HISTORIC LANDMARK COMMISSION  
STAFF REPORT

Kimble Shaw, Major Alteration, 470-08-10,  
30 North S Street in the Avenues Historic District  
June 4, 2008

1. construct a detached garage; and
2. remodeling existing structure at approximately 30 North S Street, an interior property.

**WEST ELEVATION STUDY**  
SCALE 1/8" = 1'-0"

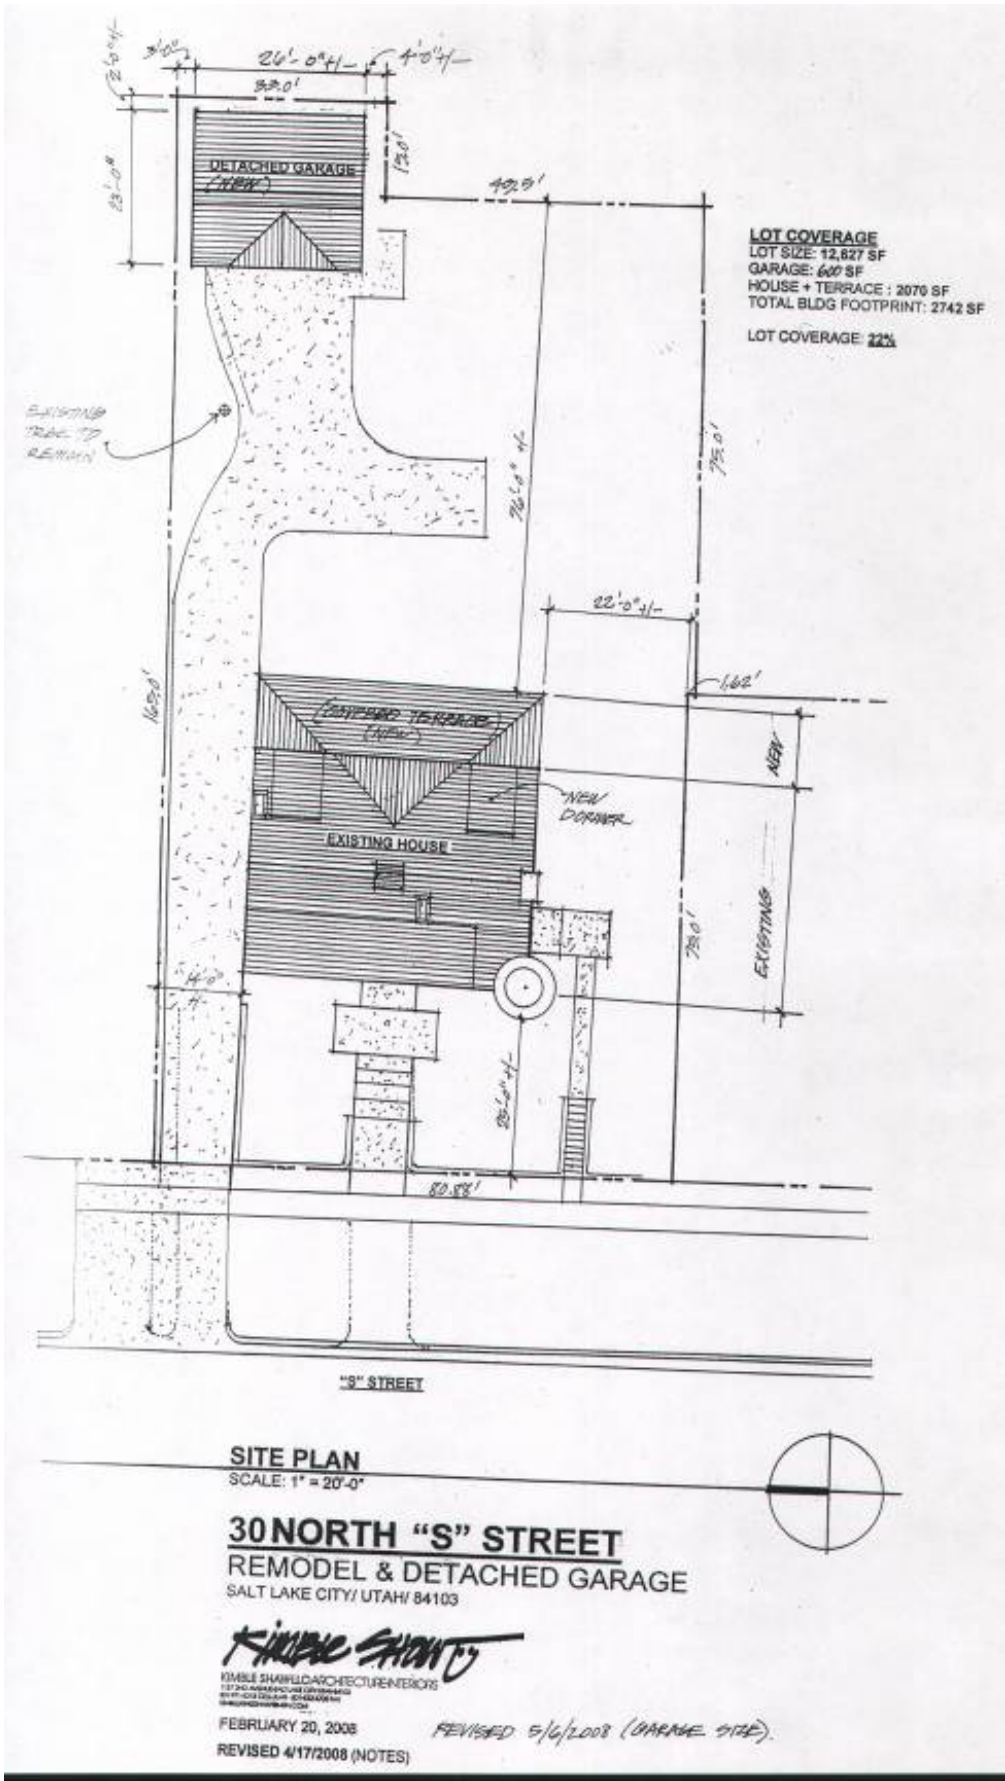
- Replace all existing wood windows with aluminum clad wood windows
- Remove existing door and replace with windows and add new wood barn door on sliding rack

The current garage door, which is not original, is proposed to be removed for a sliding barn door. The design of the sliding door comes from a sliding door and hardware found stored inside the building; however, staff believes that the stored door might have been a later addition, and not original. Staff could not find a sliding door design, like the one proposed, on early 1900s stables but found them on barns. Attachment G shows two stables designed by Frederick Hale, neither of which used a sliding barn door. In addition, the bottom of the structure has a slight flare making it unlikely that a sliding door was used. **Staff recommends that the design of the stable/garage entrance be changed so that the glazing in the entry is reminiscent of an outward opening, double door, stable entrance and the sliding barn door be removed.**

- The rear existing door and transom be relocated to the proposed north or south side entrances, if possible;
- The front stable/auto entrance be redesigned with glazing similar to the design of a historic stable door and without the sliding barn door; and
- A date stone be added to the proposed garage.

**SOUTH ELEVATION STUDY**  
SCALE 1/8" = 1'-0"

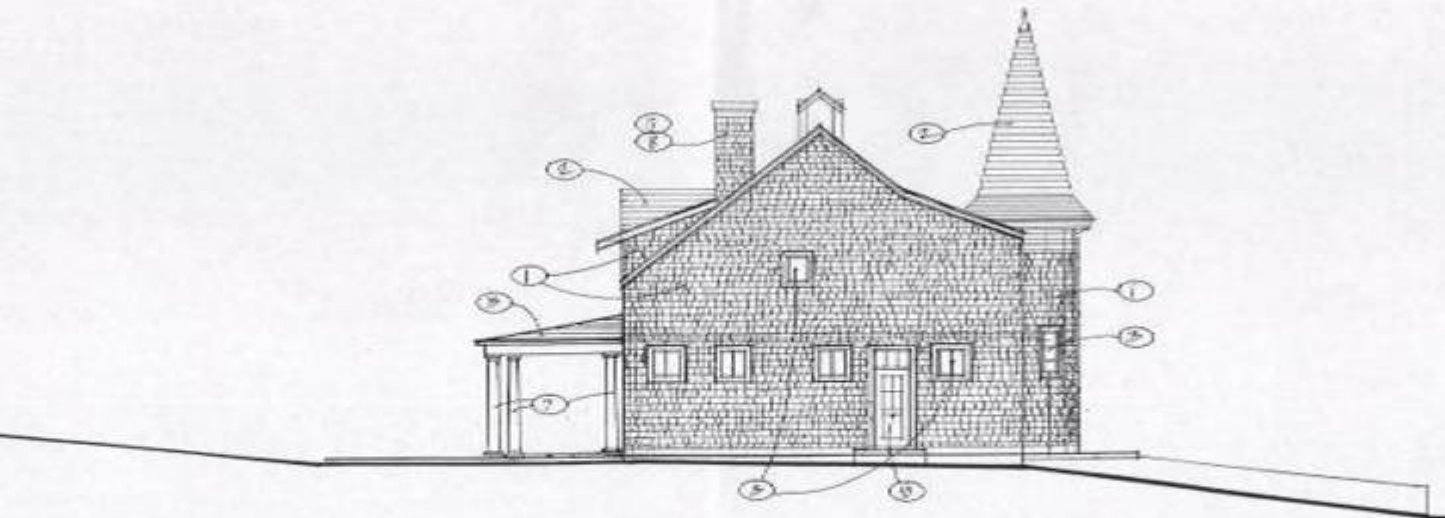
- Replace the smaller upper story window with a new aluminum clad wood window with insulated glass and simulated divided lights to match the size of the larger upper story window and replace the larger window with an aluminum clad window of the same size as the existing.
- Change the existing lower wood window to a wood panel door with three-light transom
- Remove the existing paired-door entry and overhang and replace with a large aluminum clad wood boxed window with insulated glass and simulated divided lights to match the size of the double entry.
- Remove the existing gable above the paired-door entry and replace with an 8" to 10" deep shed roof overhang of copper.

Doors: The paired doors of the south elevation, a secondary elevation, will be removed and enclosed with a boxed window the same size as the combined paired entry. The gable above will be replaced with a copper shed roof. A new single door will be added to the North and a window on the south elevation will be changed to a door. These two new doors will match the design and materials of the existing single door on the east elevation. The door and the majority of the first floor wall of the east elevation (rear) will be removed and replaced with glass. Evidence of ghosting suggests that there was a large stable door on the east side, roughly opposite of the door on the west side.

**NORTH ELEVATION STUDY**  
SCALE 1/8" = 1'-0"

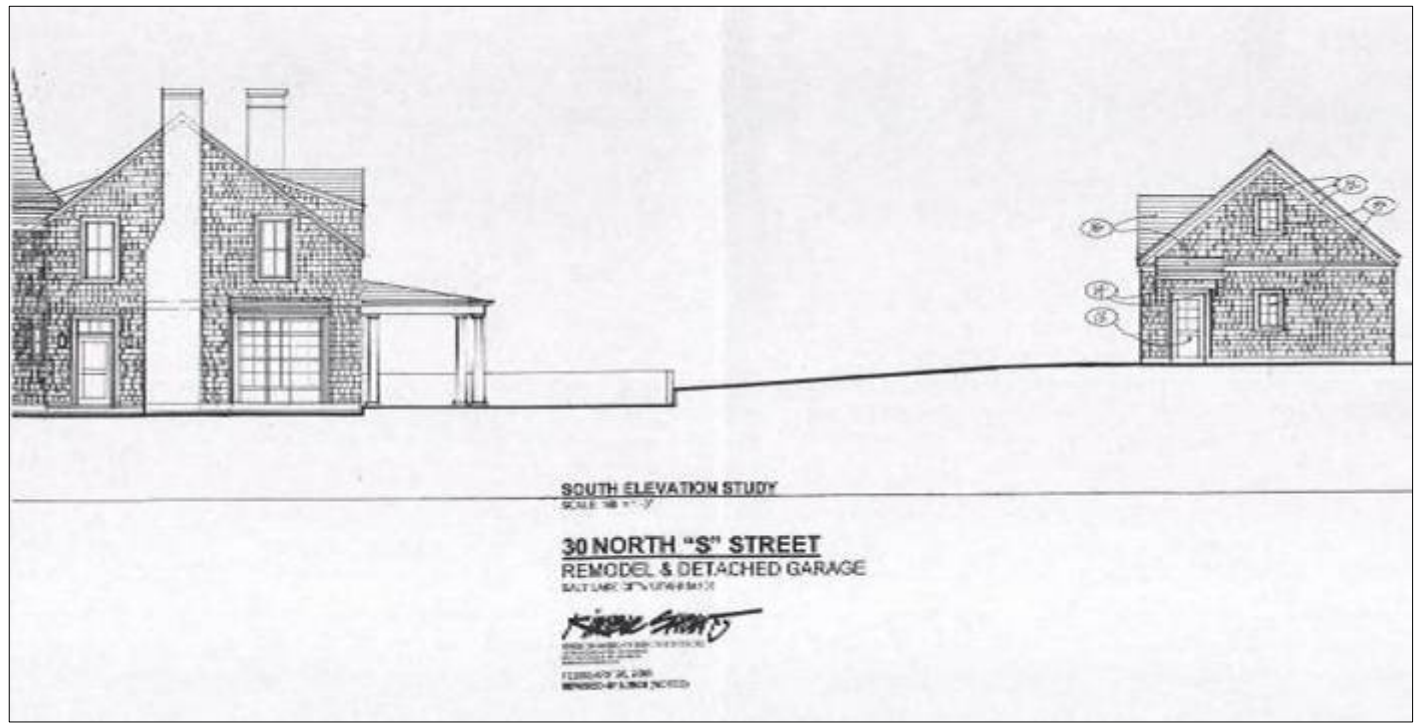
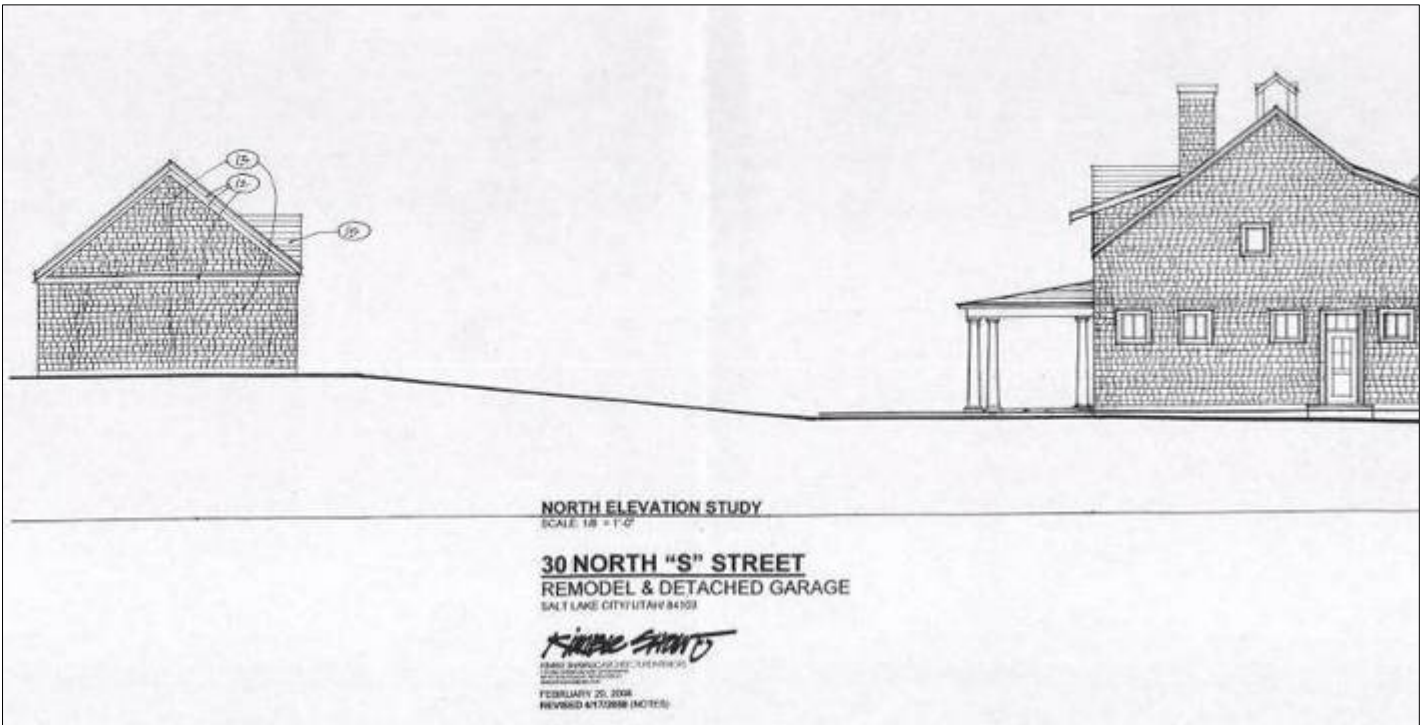
- Replace the upper story window and the far right window with new aluminum clad wood windows with insulated glass and simulated divided lights to match the existing size. (The ground floor windows will remain.)
- Add a new wood paneled door with three-light transom
- Chimney was removed before the current owner's purchase of the property

**WEST ELEVATION STUDY @ DETACHED GARAGE**  
 SCALE: 1/8" = 1'-0"

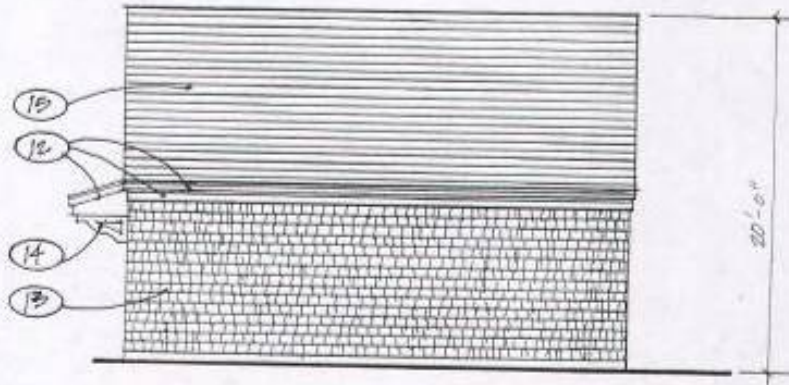
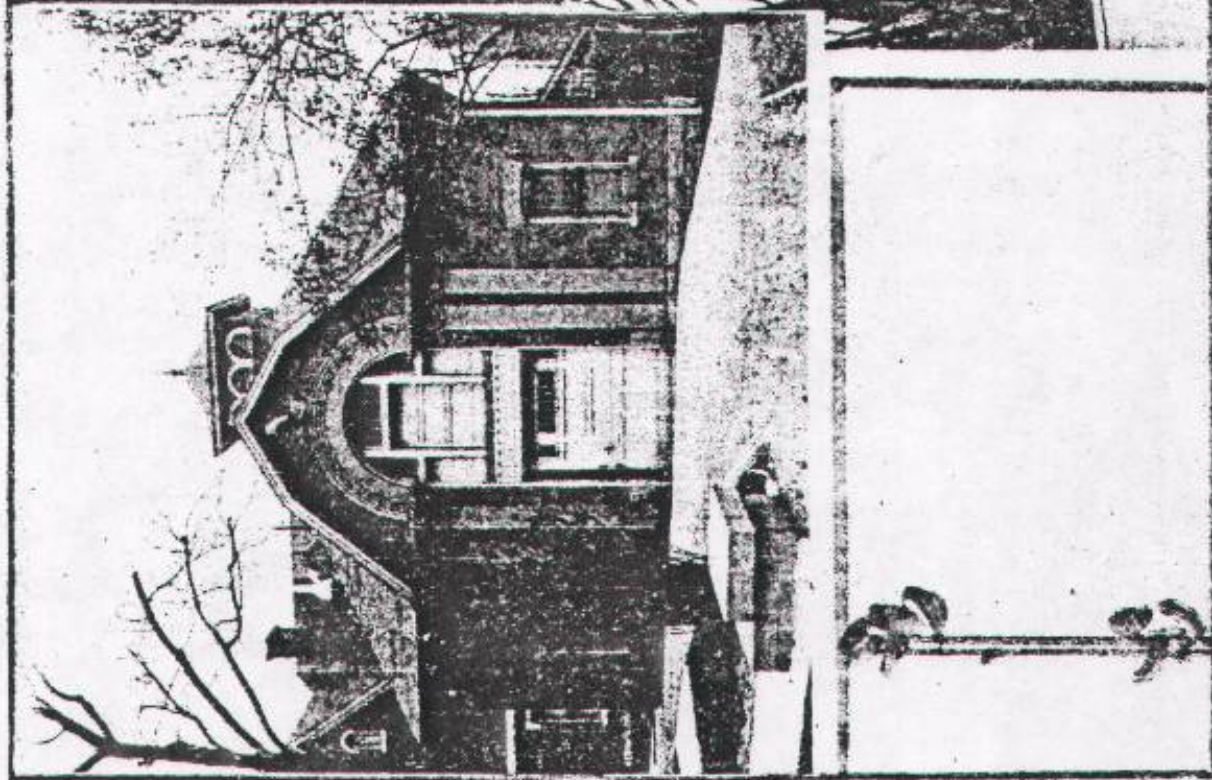
**Discussion:** The height of the garage is proposed to be twenty feet (20'). Even with the increase in grade towards the rear of the property, the garage will not be taller than the existing structure. The current one and one half story structure was designed as an accessory structure to 1205 South Temple, setting an historic precedence for large accessory structures.

Garage: According to the 1911 Sanborn maps, a large “private auto structure” was located in the same general location as the proposed garage. The proposed garage matches the existing structure in design and materials. A portion of the garage will be seen from the street, down a long driveway but it will not be readily visible from the street.

**Finding for Standards 2, 3, 5 and 8:** Garage: There is no documentation of what the original “private auto structure” looked like so the applicant chose to design a garage that matches the existing structure, much like the original designer chose to design the stable house to match the main dwelling at 1205 South Temple. **Staff recommends the addition of a date stone somewhere on, or inside, the structure to help identify it as a contemporary building.** The addition of the garage does not alter the historic character of the site.

**Finding:** Staff recommends that the Historic Landmark Commission approve the additional height of six feet (6') because of the historic precedence for one and one half story accessory structures and because the garage will be visually subordinate to the existing structure.
